FEDERAL ENERGY  
REGULATORY COMMISSION

FERC Project Nos. 2525,  
2595, 2522, 2546, 2560, and  
2581

The order modifying and approving the water quality monitoring plans for the Caldron Falls Hydroelectric Project (FERC Project No. 2525), the High Falls Hydroelectric Project (FERC Project No. 2595), the Johnson Falls Hydroelectric Project (FERC Project No. 2522), and the Sandstone Hydroelectric Project (FERC Project No. 2546), the Potato Rapids Hydroelectric Project (FERC Project No. 2560), and the Peshtigo Hydroelectric Project (FERC Project No. 2581) dated either September 14, 1998 or September 15, 1998 states that the licensee (Wisconsin Public Service Corporation, WPSC) shall determine the location of the monitoring equipment in consultation with the Wisconsin Department of Natural Resources (WDNR). If the licensee and the WDNR cannot agree on a location for the monitoring, the licensee shall file its recommendations, along with the WDNR comments, for Commission approval.

SUBJECT: Proposed Water Quality Monitoring Device Locations, FERC Project  
Nos. 2560, 2525, 2522, 2546, 2595, and 2581

Figure 5

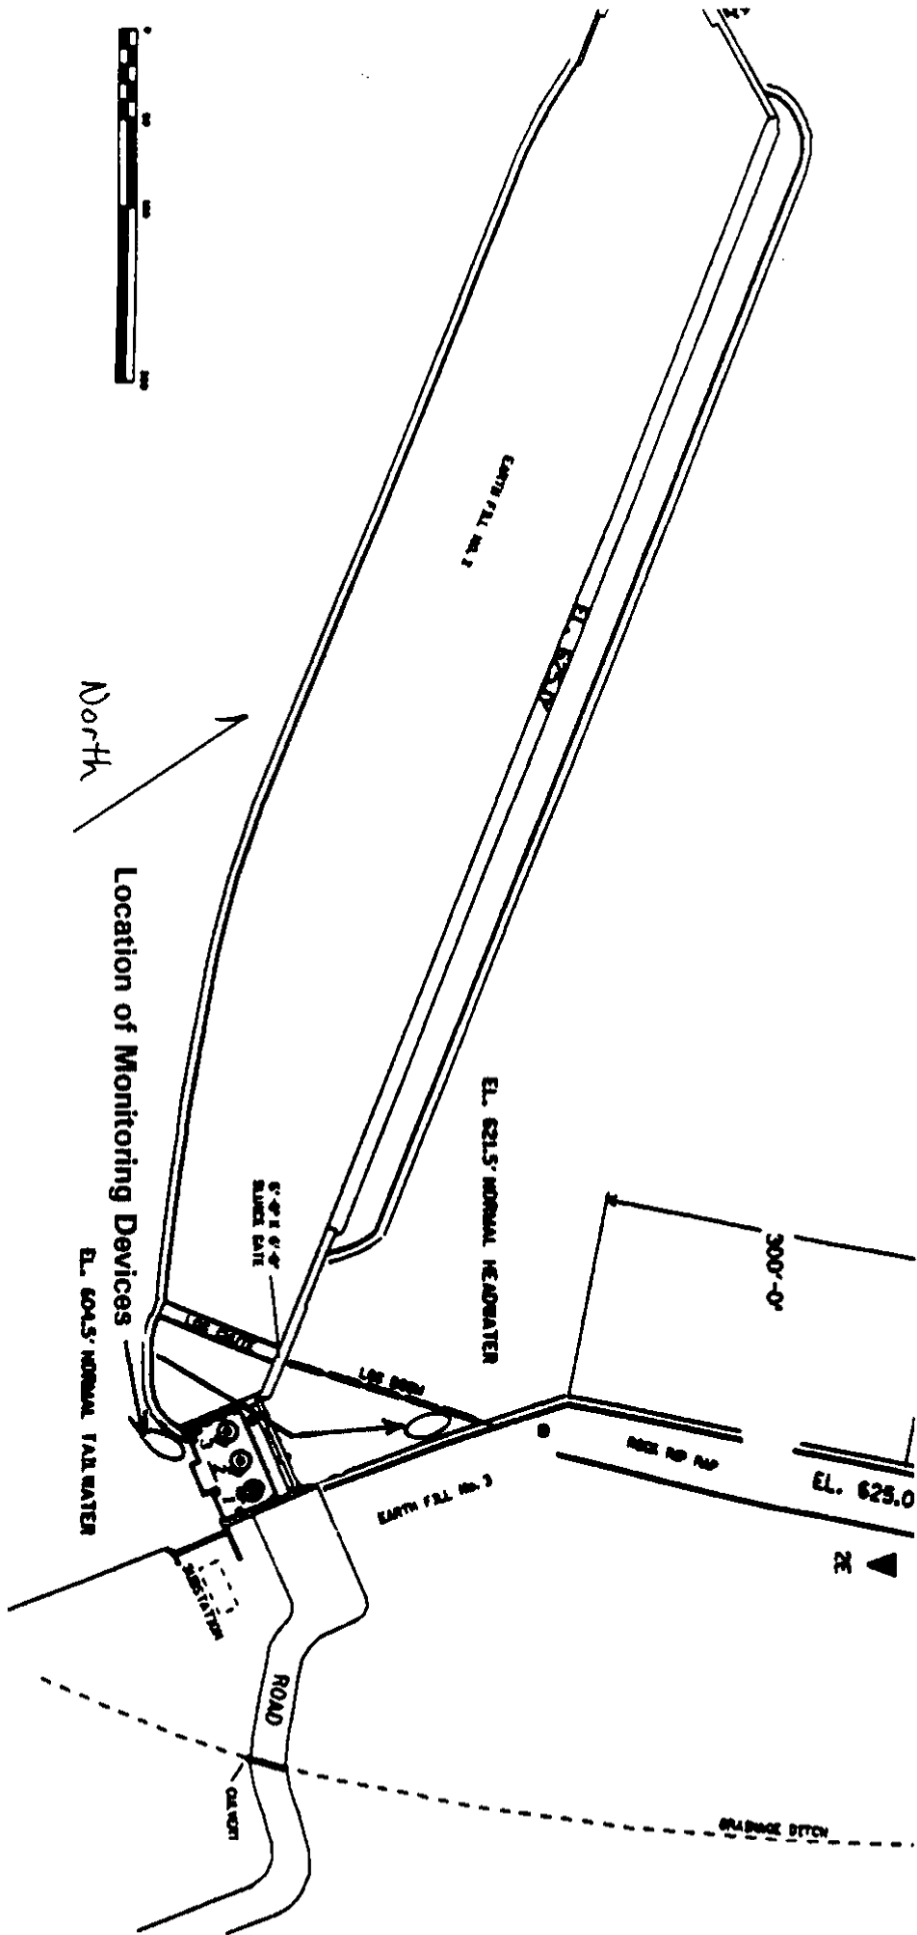
Figure 5 depicts the placement of the monitoring devices in relation to the dam structure. The location of the upstream monitoring device has been modified by moving the location approximately 100 feet to the north along the wingwall away from the powerhouse to address the concerns associated with the operation of different turbine units provided in the WDNR comments. The location of the downstream monitoring device will remain the same as the location utilized for the relicensing water quality monitoring. The structure for retaining the water quality monitoring device remains in place and requires no modification for the proposed location. The proposed location is in the tailwater outfall and is attached to the dam structure itself. WPSC does not believe it is necessary to determine the exact location of the monitoring device through a site visit with the WDNR because the past consultation record has proven an agreement on the locations is unlikely. The placement of the monitoring device is influenced by safety, ease of access, and protection from vandalism and theft. These factors are apparently not considered by the WDNR. Therefore, WPSC is providing an approximate location in the recommendations that will provide a format (location within the stream, proximity to the dam, etc.) which allows the agency concerns about the quality of data to be addressed.

The location that you are proposing for the upstream monitoring device is unacceptable to the Wisconsin Department of Natural Resources (WDNR). By placing the device at the northeast corner of the powerhouse you will not get a representative sample of the water quality above the project. With the operation of different turbine units at different times of the year there will be varying flow patterns coming into the powerhouse. This will impact water quality. We would suggest that you look for a location in the vicinity of the County Highway E bridge located above the impoundment. The exact locations of both the upstream and downstream water quality monitoring devices should be determined at an onsite meeting with representatives of the agencies.

The proposed location of the upstream monitoring device has been modified by moving the location approximately 100 feet to the north along the wingwall away from the powerhouse to address the concerns associated with the operation of different turbine

units provided in the WDNR comments. The location of the downstream monitoring device will remain the same as the location utilized for the relicensing water quality monitoring. The structure for retaining the water quality monitoring device remains in place and requires no modification for the proposed location. The proposed location is in the tailwater outfall and is attached to the dam structure itself. WPSC does not believe it is necessary to determine the exact location of the monitoring device through a site visit with the WDNR because the past consultation record has proven an agreement on the locations is unlikely. The exact placement of the monitoring device is influenced by safety, ease of access, and protection from vandalism and theft. These factors are apparently not considered by the WDNR. Therefore, WPSC is providing an approximate location in the recommendations that will provide a format (location within the stream, proximity to the dam, etc.) which allows the agency concerns about the quality of data to be addressed.

Caldron Falls Water Quality Monitoring Device Locations

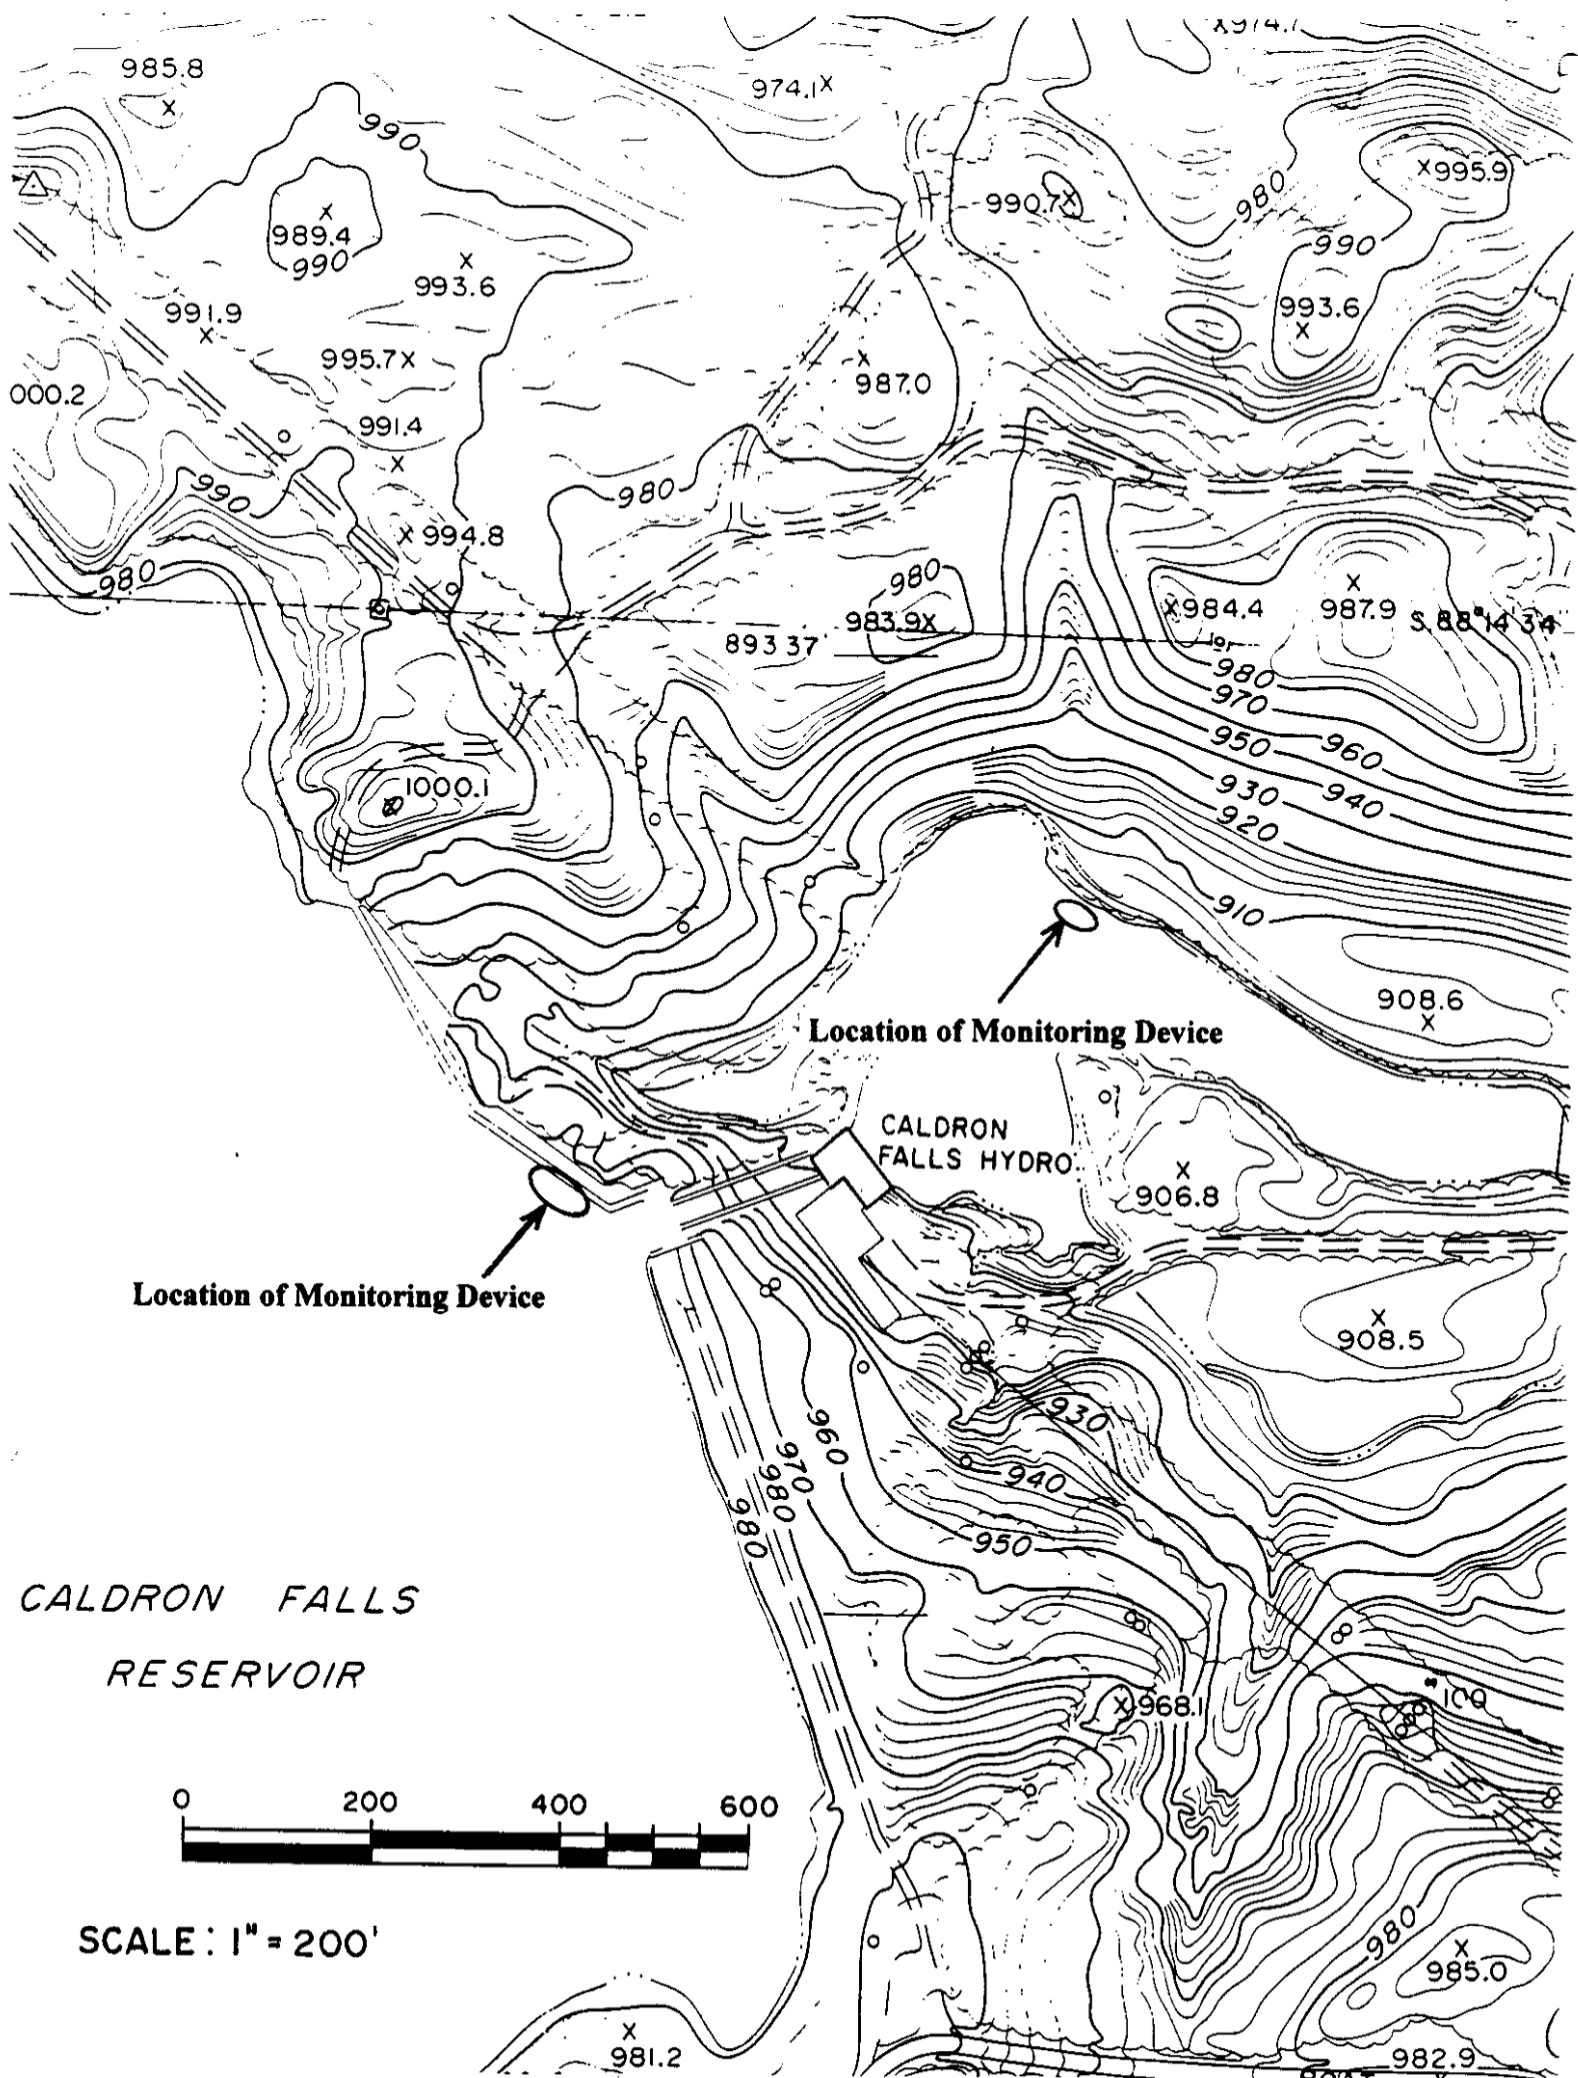
Both the up and downstream locations that you have proposed for monitoring water quality at this project are unacceptable to us. The water quality-monitoring device should be placed above the flowage somewhere in the vicinity of the County Highway C Bridge. The location that you are proposing near the intake structure will not provide accurate information on the water quality entering the project. Similarly the site you are proposing below the project will not provide meaningful information on water quality below this project. We are concerned with the water quality in the pool immediately below the powerhouse. The location for the water quality monitoring device that you are proposing will not adequately represent the water quality in this pool. Article 409 of your license requires that water quality be monitoring immediately downstream of the dam.

The upstream monitoring device is proposed to be placed in a location that will assure that any dissolved oxygen levels that are below the state standards are not due to the operation of the facility. The WDNR request for monitoring above the flowage is unnecessary. Past monitoring of dissolved oxygen has proven that the dissolved oxygen situation is due to stratification of the reservoir. The idea of monitoring above the flowage to take into account any low dissolved oxygen conditions coming into the river system upstream is unnecessary because the river upstream from the project originates and flows through an undeveloped forested setting, which has no recorded point discharges and very little agricultural land. Furthermore, the entire Caldron Falls shoreline is under the ownership of WPSC and is kept in an undeveloped state, with the exception of project facilities. The river upstream of the reservoir is not representative of the conditions in the reservoir. The WDNR request for monitoring above the flowage is based upon the supposition that the presence of the reservoir is a direct result of project operations or “flow releases” which Article 409 is designed to monitor. WPSC retains the position that the reservoir is an existing feature that produces many benefits, including those for recreation and the fishery and the presence of the reservoir is an issue that is separate from the objective of Article 409. Therefore, the naturally occurring phenomenon (stratification) that occurs in the reservoir is not required to be monitored. Only the flow release from the project should be monitored and the WPSC recommendations for the location of monitoring devices reflect their flow release position.

The downstream monitoring device is proposed to be placed in a location that will determine the effectiveness of measures WPSC has implemented to increase the levels of dissolved oxygen in the tailwater. WPSC has been implementing efforts to increase the dissolved oxygen content of the water in the tailwater by redirecting water passed through the sluice gate directly into the tailrace. The warmer water (high in dissolved oxygen) does not immediately mix with the colder water (low in dissolved oxygen) leaking

through the wicket gates due to the water density differences. Therefore, WPSC is proposing to monitor the dissolved oxygen in a location which represents the conditions of the water being passed downstream of the project by monitoring in a location where complete mixing of the two types of water has taken place. A place that is within 300 feet of the tailrace structure or immediately downstream of the dam (See Figure 1).

High Falls Water Quality Monitoring Device Locations

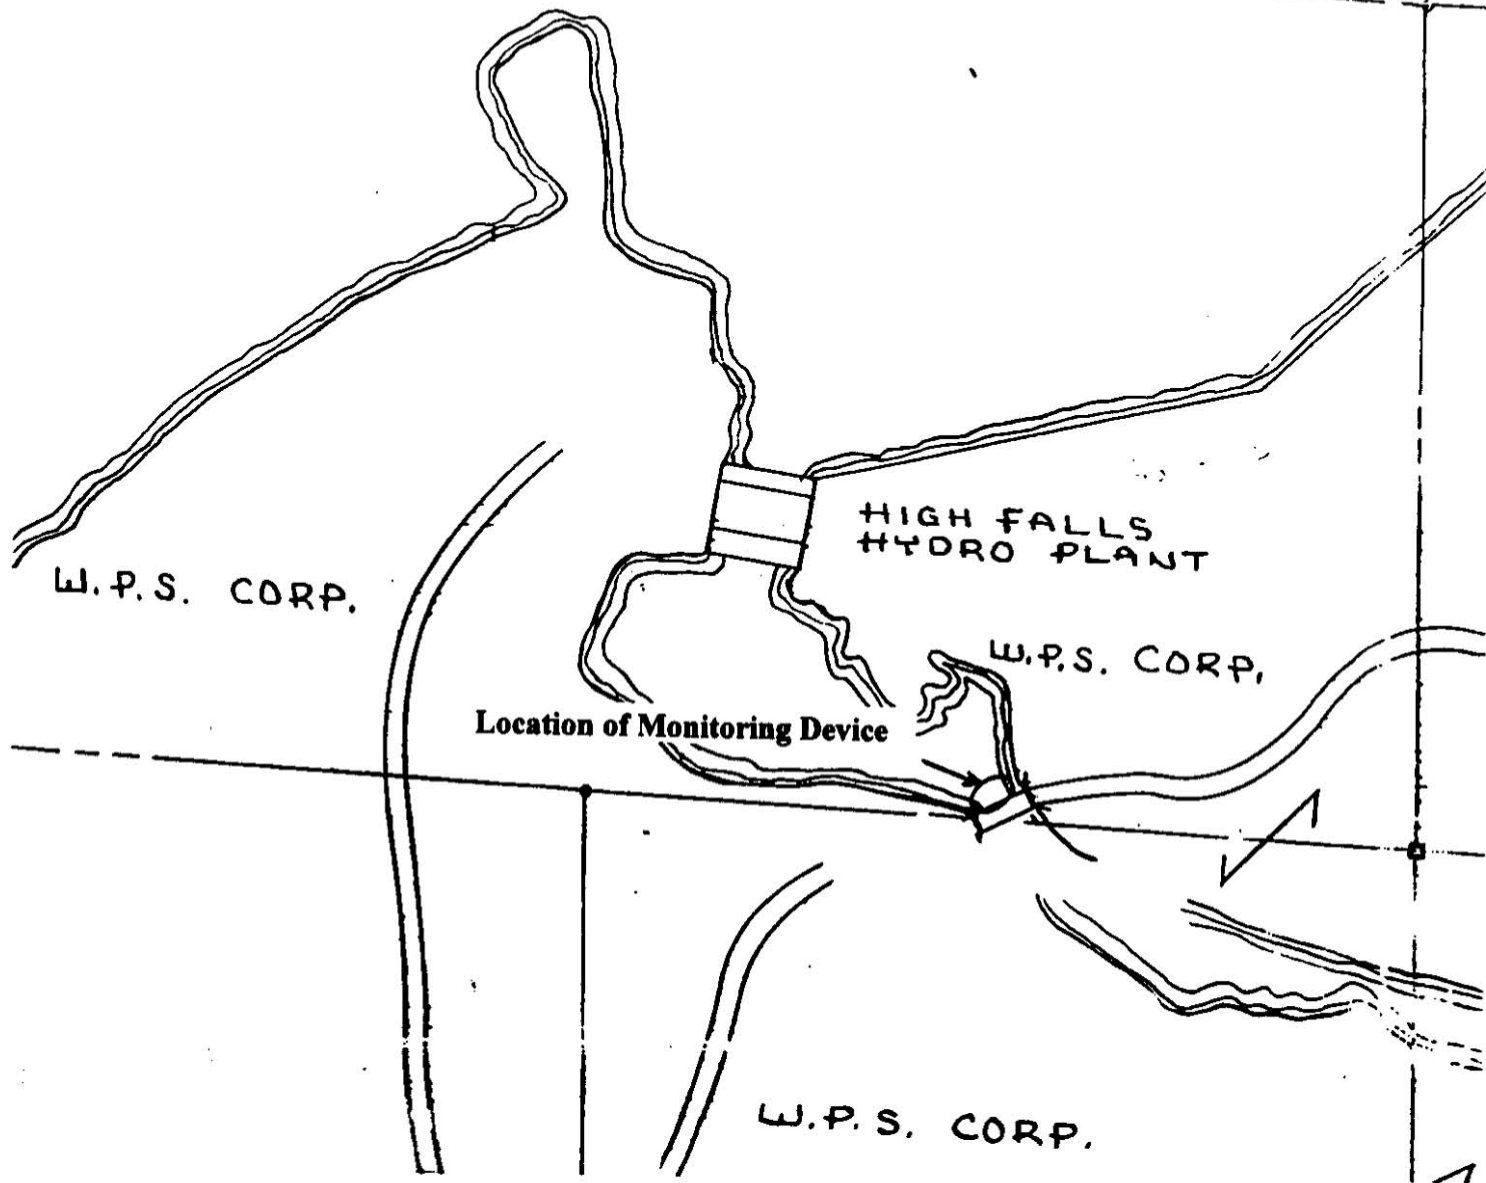
The location you are proposing for the water quality monitoring device below the High Falls Project appears to be in a reasonable location, however we would suggest that the exact location be selected with the agency personnel during a site visit.

The proposed location of the downstream monitoring device is near the middle of the river and is attached to the concrete column supporting the bridge. WPSC does not believe it is necessary to determine the exact location of the monitoring device through a site visit with the WDNR because the past consultation record has proven an agreement on the locations is unlikely. The exact placement of the monitoring device is influenced by safety, ease of access, and protection from vandalism and theft. These factors are apparently not considered by the WDNR. Therefore, WPSC is providing an approximate location in the recommendations that will provide a format (location within the stream, proximity to the dam, etc.) which allows the agency concerns about the quality of data to be addressed.
